# Brooklyn Community Board #1 Response to USACE NYNJHATS Storm Risk Management Draft Plan

Based on a United State Army Corps of Engineers (USACE) presentation to Brooklyn Community Board #1 Environmental Protection Committee on November 29, 2022 (isolated slides below), the ensuing discussion and input received from committee and board members and the general public attending a Environmental Protection Committee hearing about the plan on January 4th, 2023, this community board submits to the USACE a response to its NYNJHATS Storm Risk Management Draft Plan (SRMP).

Newtown Creek Storm Surge Barrier

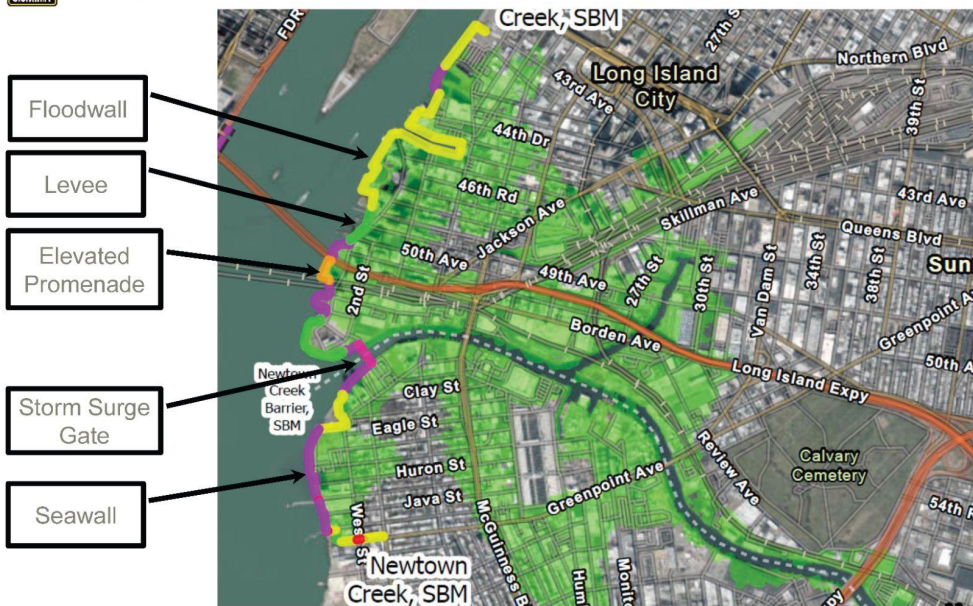
Tidal flow works to clean the creek water, especially during rain events when the 13 CSO outfalls are discharging over a billion gallons of sewage into the creek annually. We are deeply concerned that the gate, *both*, in its closed or (partially) open state will inhibit this process.

approximately 60%. We are concerned the gate in both positions could inhibit the functioning of these measures. Conversely, the *USACE could create additional infrastructure* to retain additional sewage during rain events to increase the sewage reduction percentage to well beyond 60%, a figure that the community finds grossly inadequate. Under the LTCP, over 464 millions gallons of sewage would still be discharged into the creek during rain events. Since the USACE has noted that adequate drainage must be designed into this plan, enhancing the LTCP remedy could serve dual purposes.

We are concerned about the gate interfering with the federal Superfund remediation process and its potential to cause recontamination. The superfund investigation process has already taken over 10 years, and the feasibility study, risk assessment, remedy design, Record of Decision and the remediation itself will take decades more. It would be catastrophic if this remediation project was damaged by the construction and operation of the proposed storm surge gate. The risk management plan must be designed in concert with the EPA and the community watchdog entity, the Newtown Creek Advisory Group to achieve the best and safest outcome for the remediation and storm risk management, *and* consider alternative designs for the latter.

The plan draft estimates there to be shipping delays due to surge barrier closures. Oil, garbage and sludge are just a few of the essential items that move in and out of the creek on a regular basis. The barrier would impact the vessels from shipping out sludge and other essential shipping, as well as HAZMAT emergency access that may affect the creek considering its highly contaminated state and industries existing along the creek working with noxious substances and products.

Sealing off two-thirds of the creek permanently will have severe negative consequences for the natural cleaning process the river and creek tidal action provide. This process is a key supporting element of the Long Term Control Plan. It would be much more preferable to deploy vertical lift gates instead of a narrow horizontal moving structure connected to sealed barriers, or measures with similar flexibility, that would allow much more profuse tidal flow. See rising sector gates used with [The Thames Barrier](#) which protects Central London in the United Kingdom from storm surges by utilizing raisable gates. In its open state, it will allow vessel navigation *and* promote almost complete uninhibited tidal flow. *Brooklyn Community Board #1 urges USACE to explore and consider alternatives to a structure that will not disrupt the tidal flow of Newtown Creek and prevent the potential negative consequences of utilizing a horizontal gate and solid*
